AR-07-1162

Southern Nuclear Operating Company
Vogtle Early Site Permit Application
Supplemental Response to Requests for Additional Information on Geology/Seismology

Supplemental Response to Geology/Seismology RAIs

Vogtle ESP Application

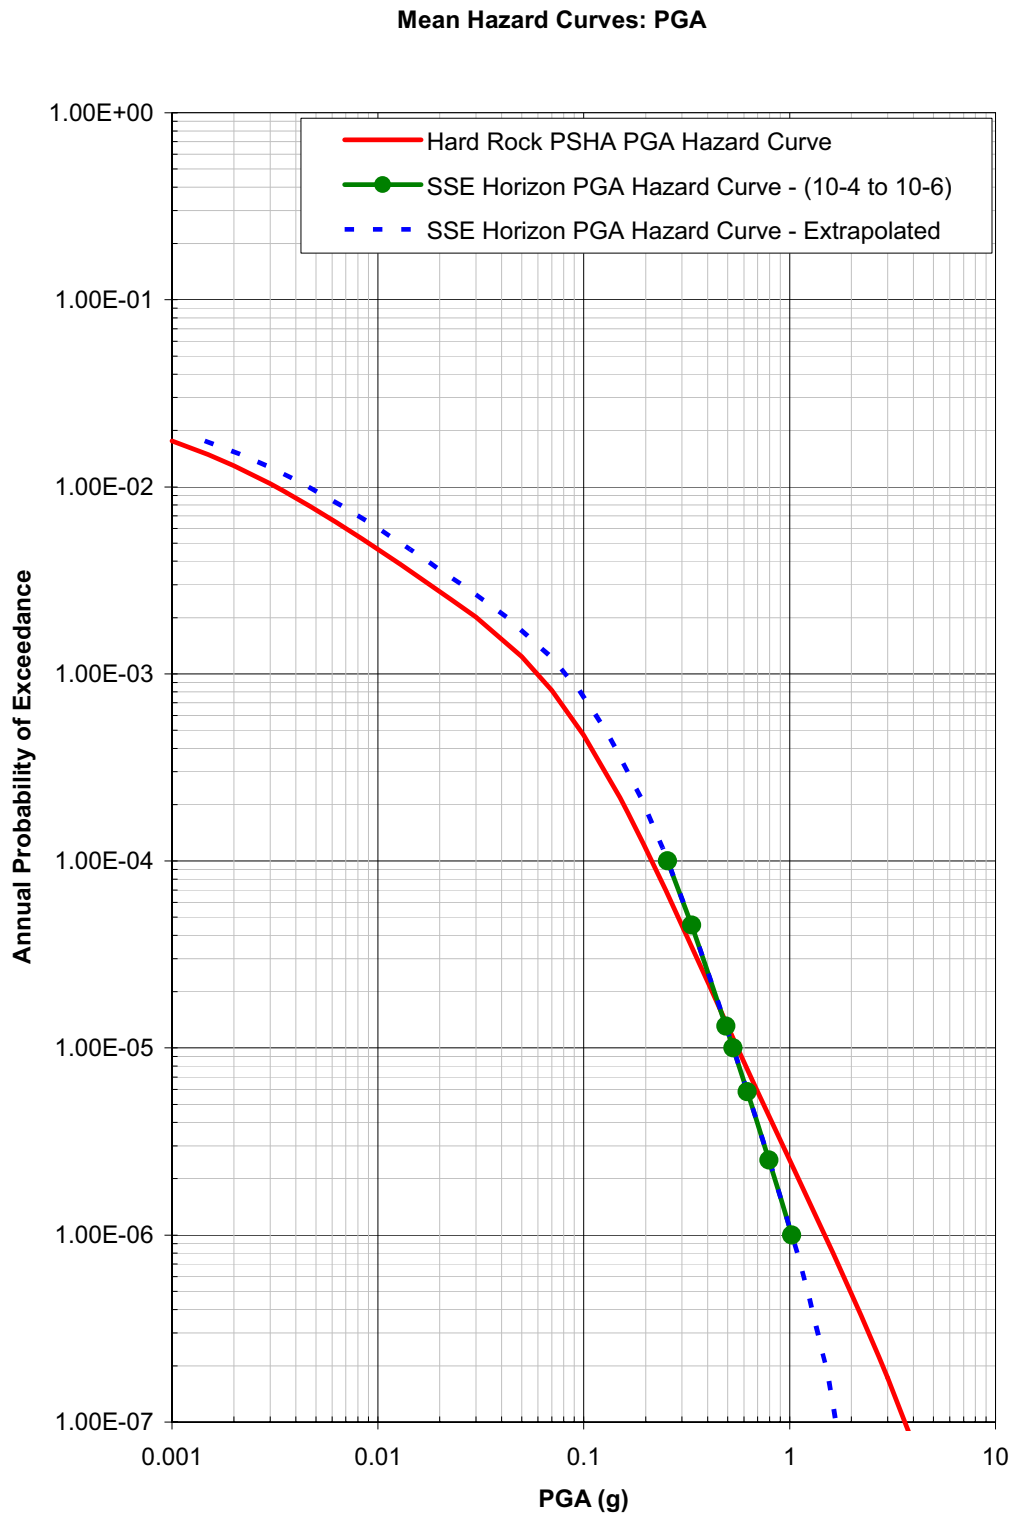
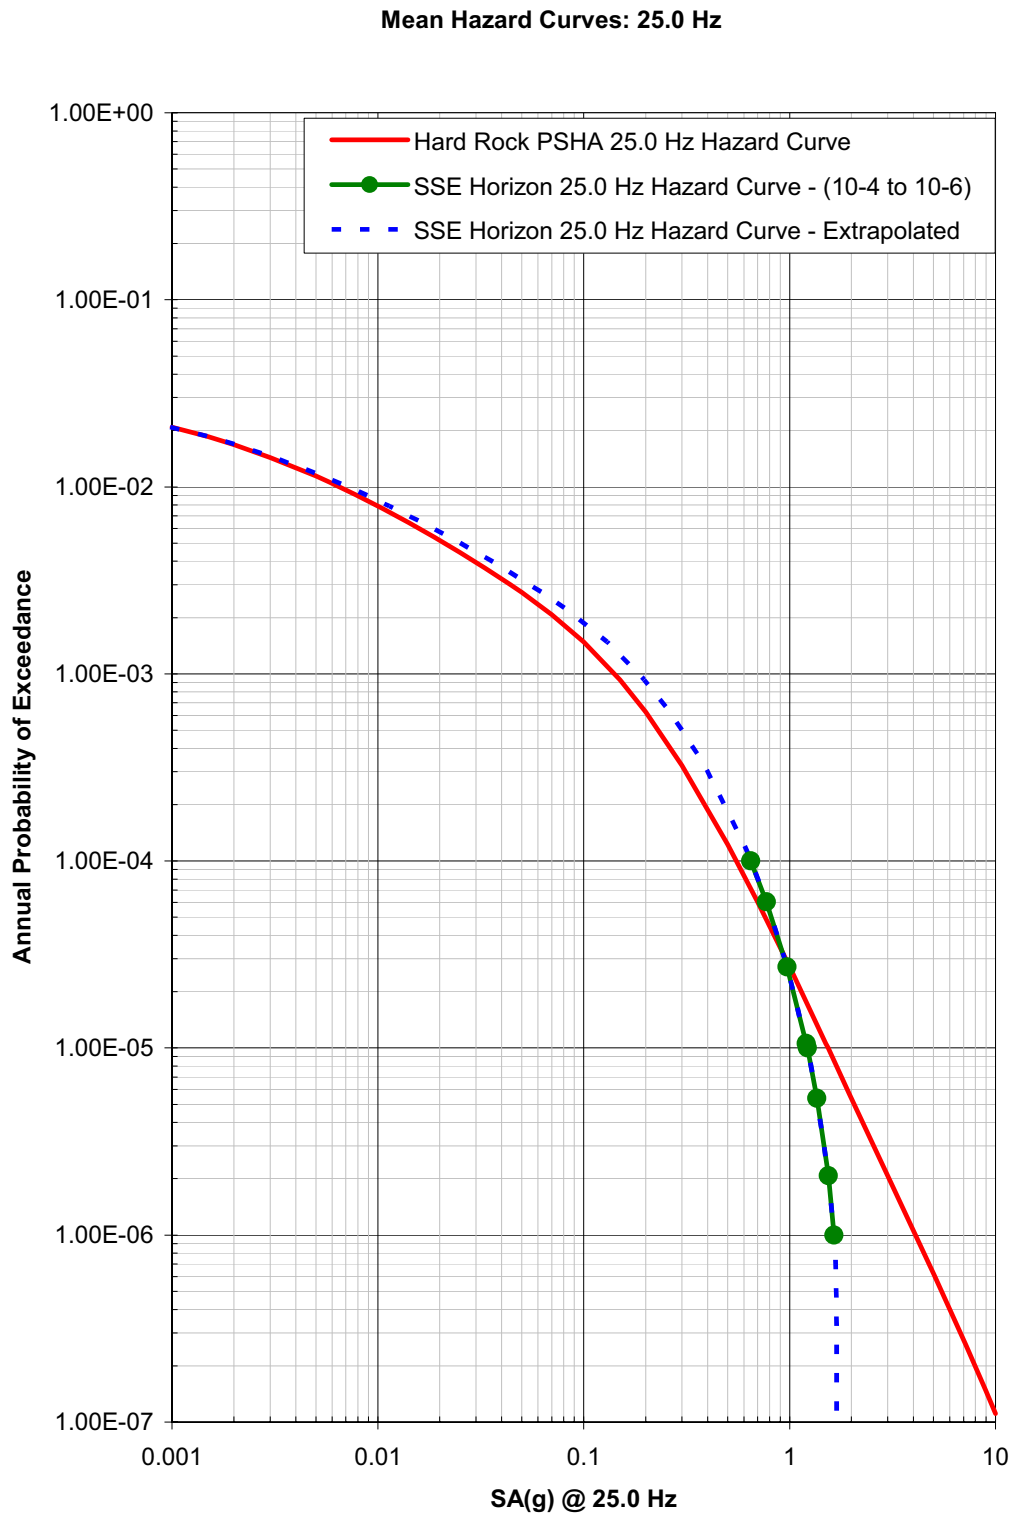
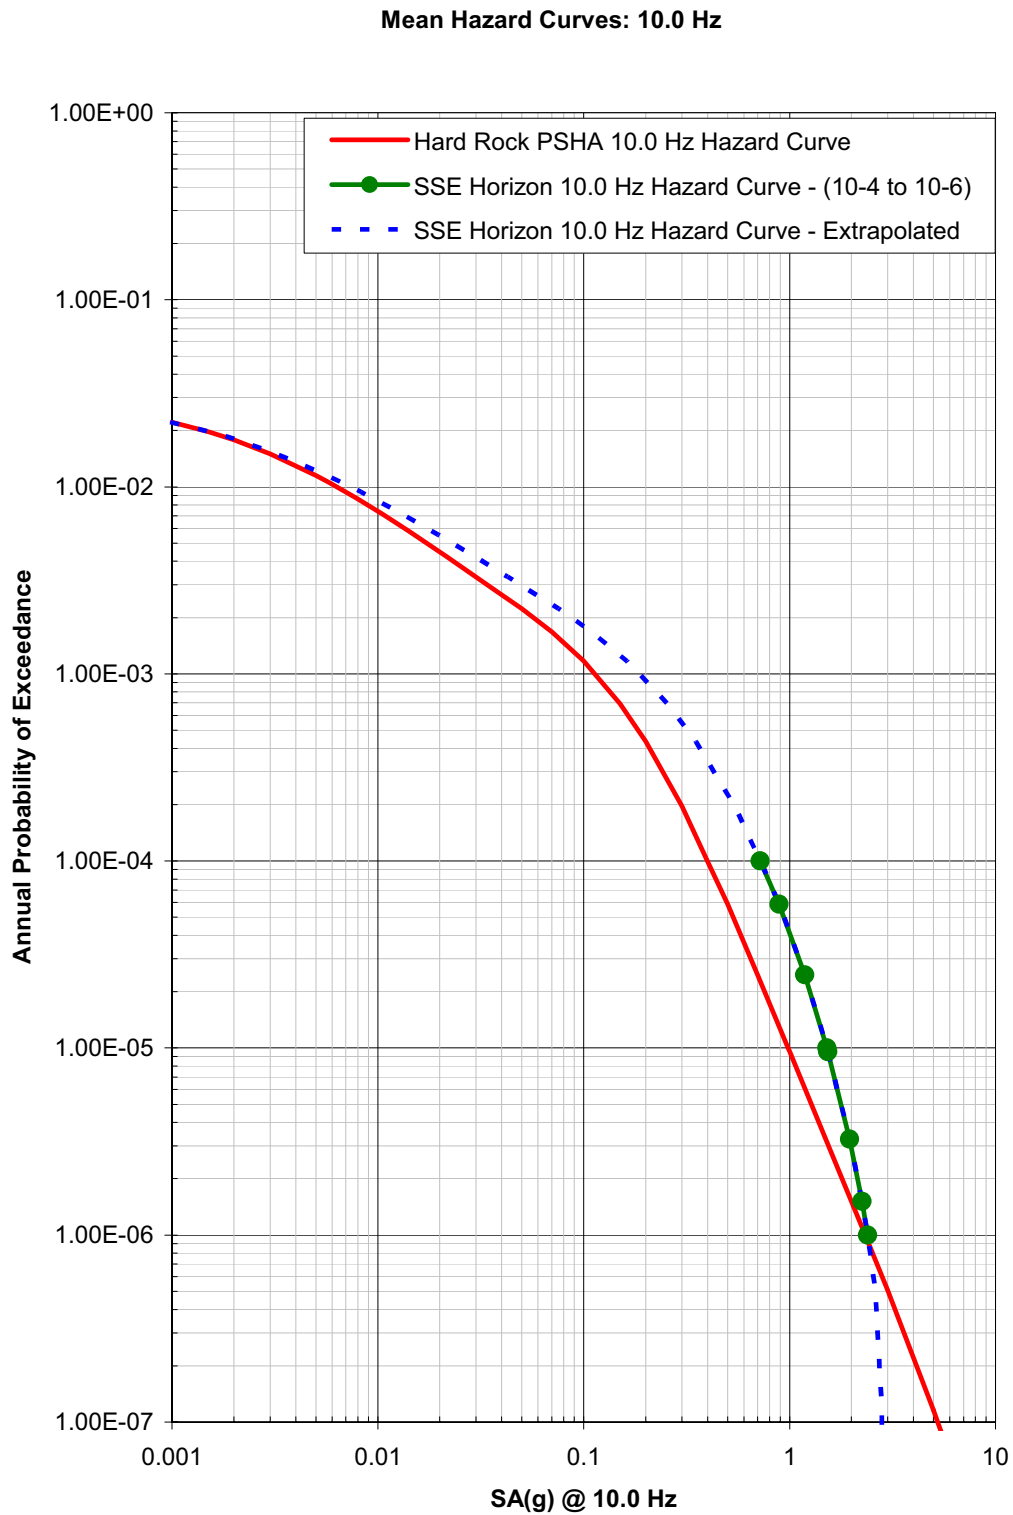
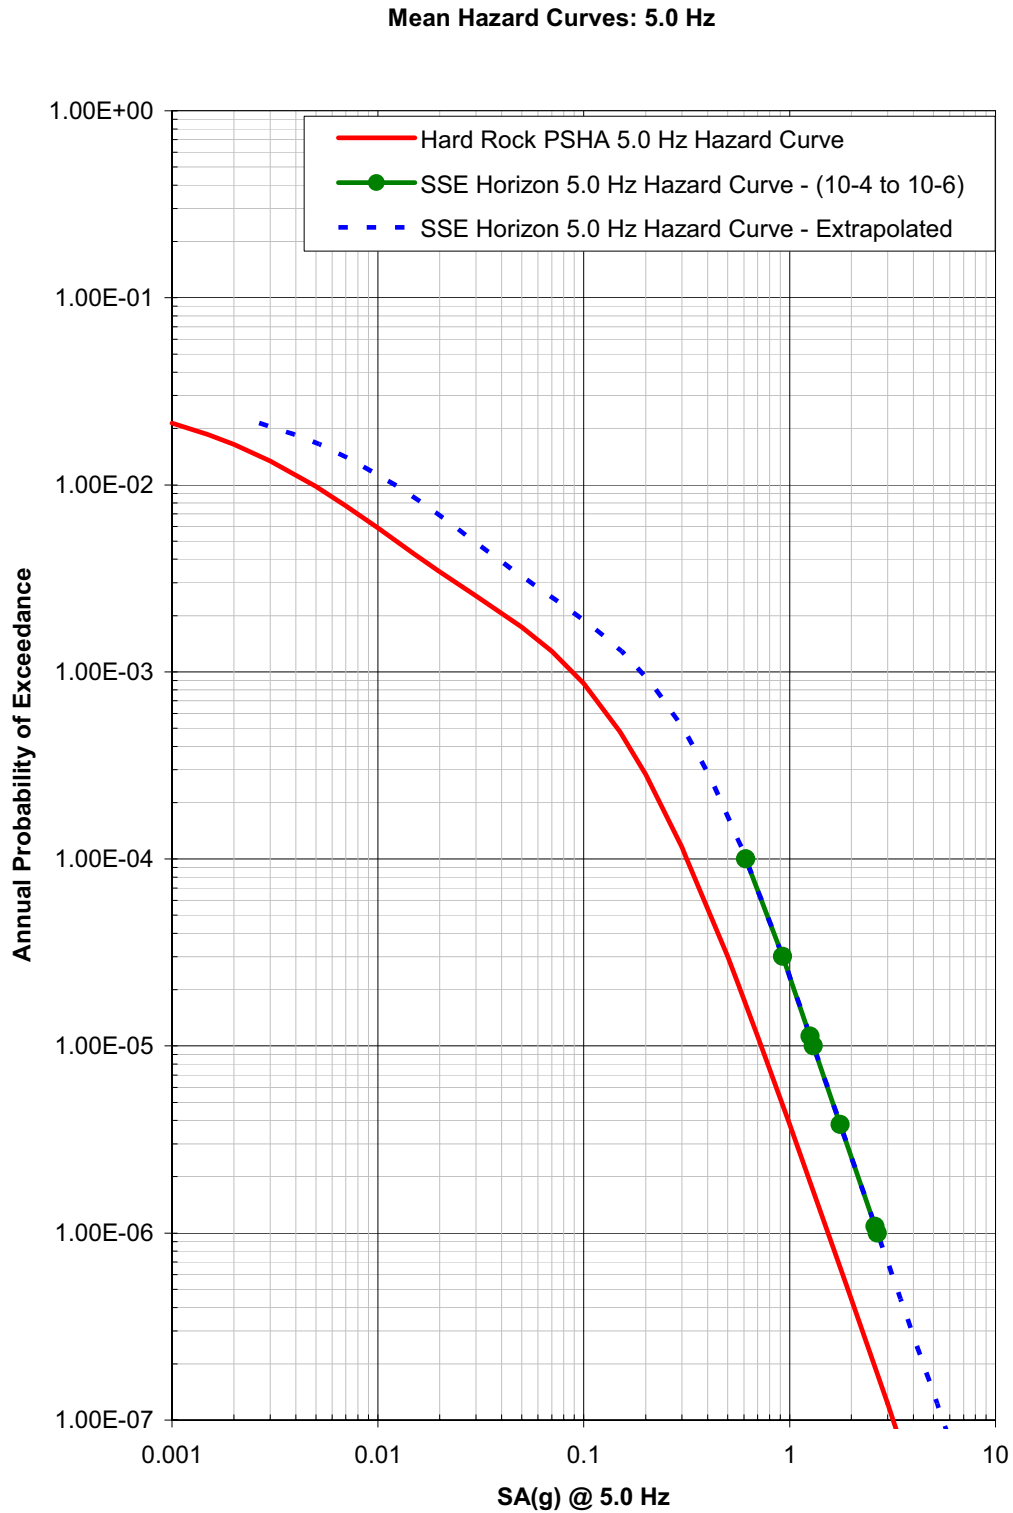
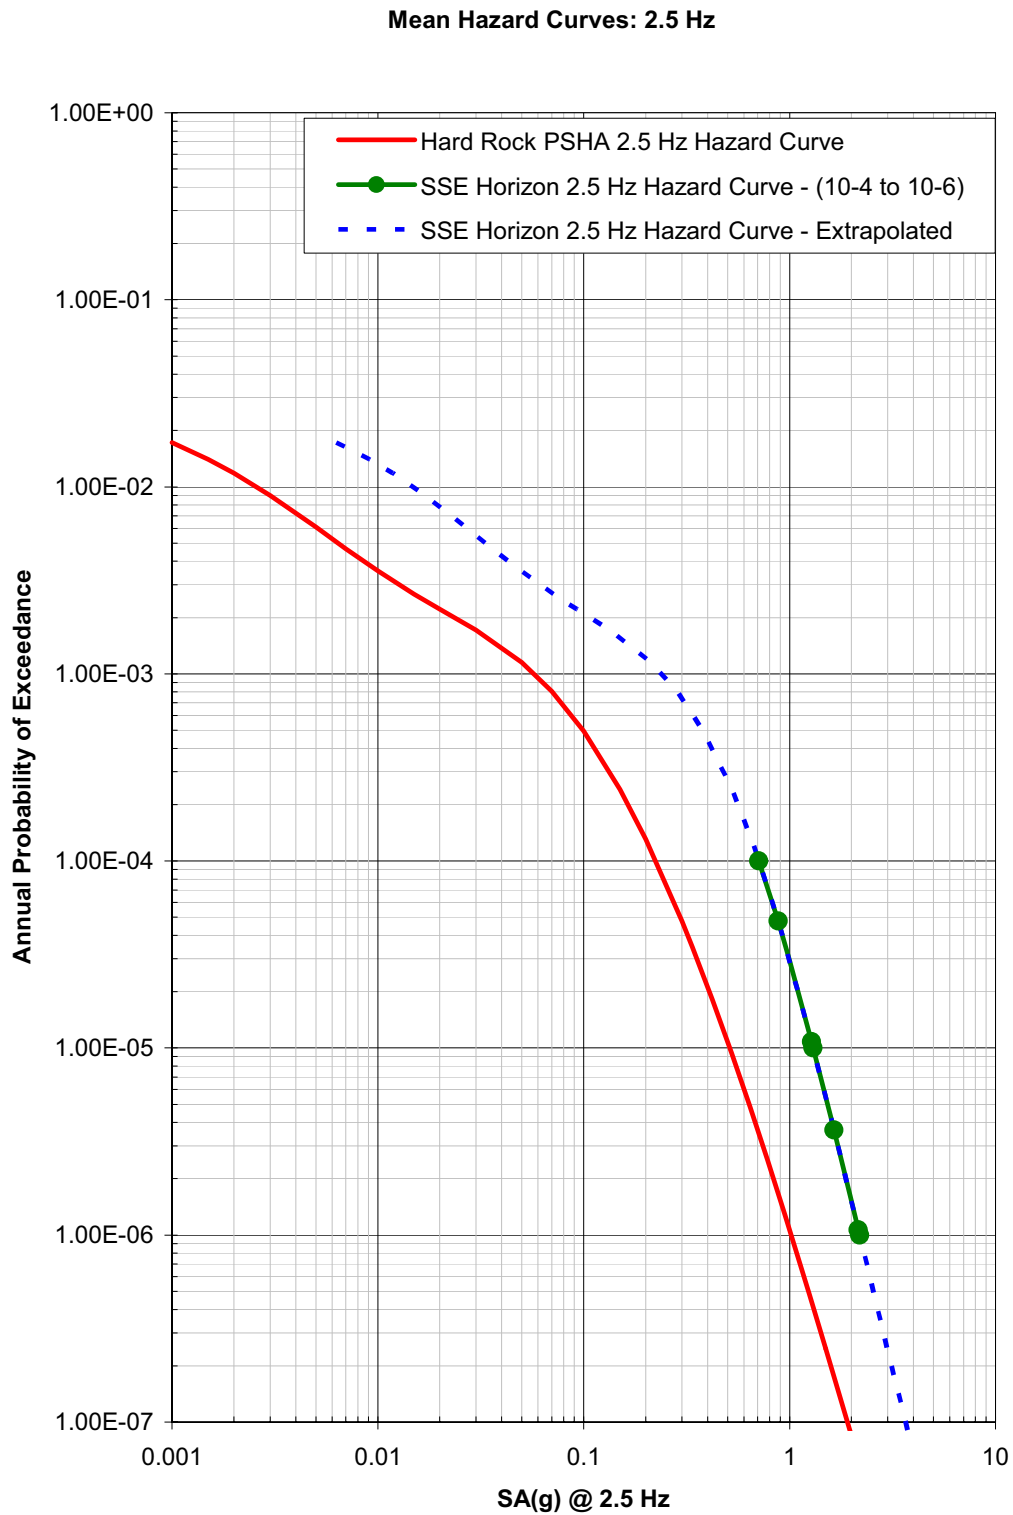
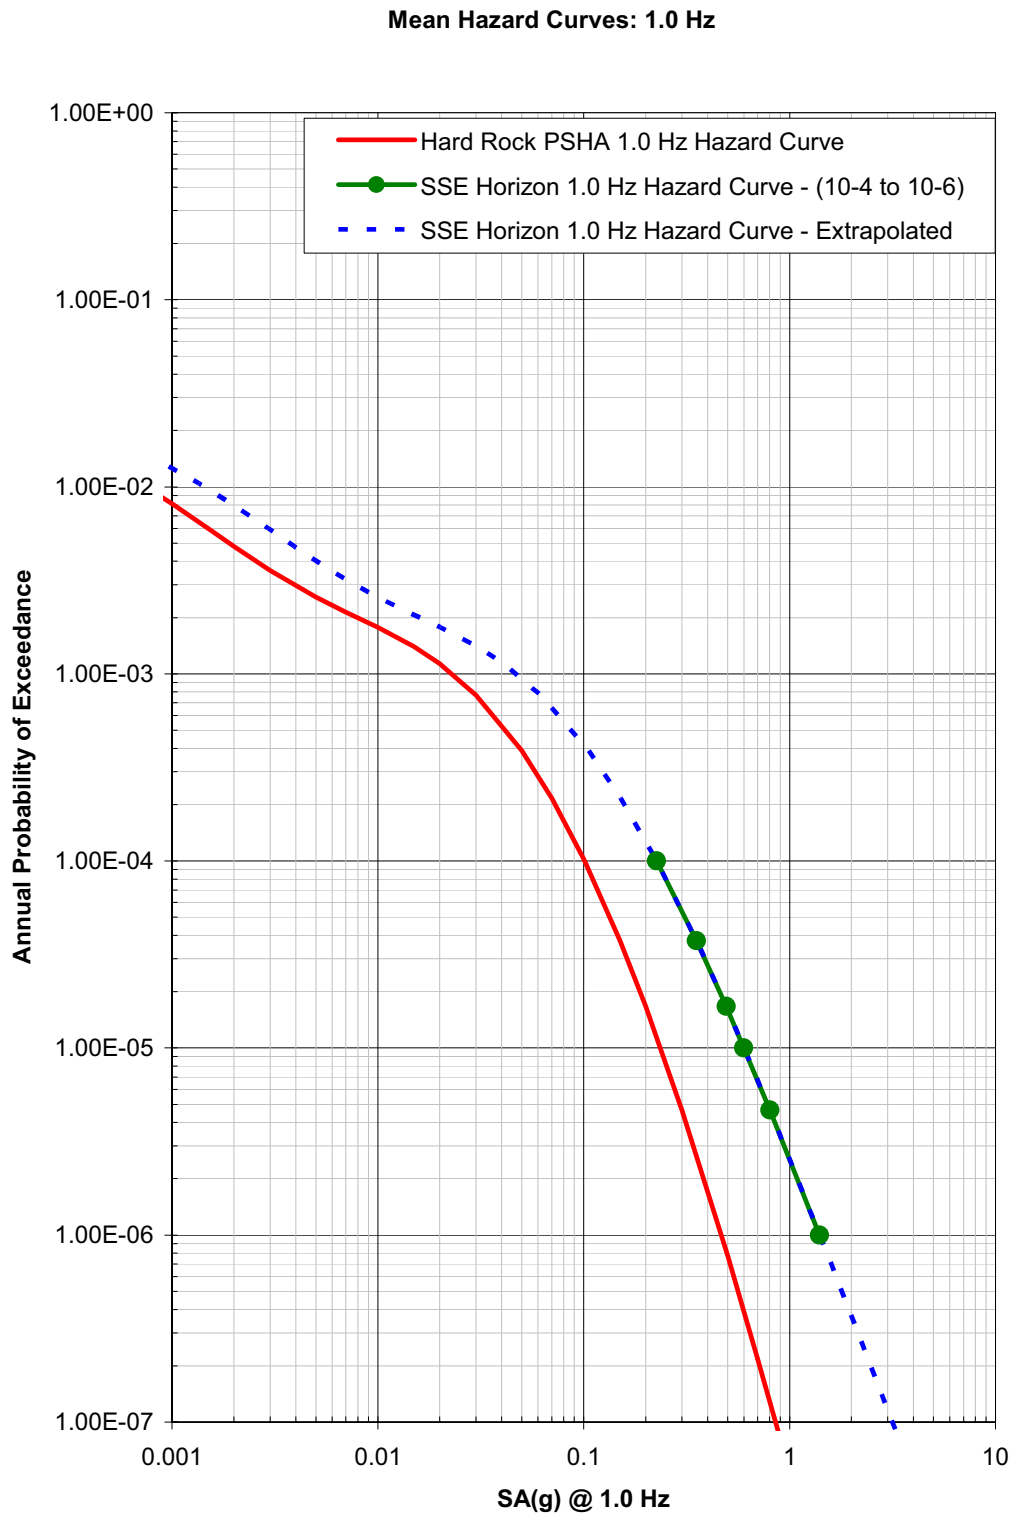
2.5.2-3 In response to this RAI, soil hazard curves were provided at three annual exceedence frequencies (10^{-4} , 10^{-5} , and 10^{-6}). However, in order for the staff to verify the adequacy of the SSE, soil hazard curves are requested at additional annual exceedence frequencies (i.e. at values between 10^{-4} , 10^{-5} , and 10^{-6}).

Next the hard rock hazard curves were scaled based on the functional amplification factor model for each frequency. The three hard rock ground motion values (see Table 1) corresponding to annual probability levels of 10^{-4} , 10^{-5} , and 10^{-6} were added to the suite of 25 points that defined the hard rock hazard curves (Risk Engineering Inc., 0521-ACR-032, 2006) prior to developing the top of Blue Bluff Marl hazard curves. For each of the seven frequencies, the top of Blue Bluff Marl seismic hazard curve was computed by scaling the hard rock ground motion values by the functional amplification model at each of the 28 annual probability level points that define the hard rock seismic hazard curves (see Table 2). A constraint was placed on the resulting top of Blue Bluff Marl hazard curves such that the resulting hazard curve does not decrease in ground motion for decreasing annual probability of exceedence levels. In cases where this constraint is applicable, the resulting top of Blue Bluff Marl hazard curve is vertical (i.e., the ground motion value is constant for decreasing annual probability levels).

The hard rock seismic hazard curves, amplification factors, and corresponding top of Blue Bluff Marl seismic hazard curves are listed in Table 2 for the seven frequencies. The three additional data points corresponding to probability levels of 10^{-4} , 10^{-5} , and 10^{-6} are indicated in bold. The hard rock (solid red line) and resulting top of Blue Bluff Marl seismic hazard curves are plotted in Figure 2. As indicated on each figure, the dashed blue line is based on the extrapolation of the amplification function beyond the range 10^{-4} to 10^{-6} and the green solid line with green circles is based on the interpolation of the amplification function over the range 10^{-4} to 10^{-6} .
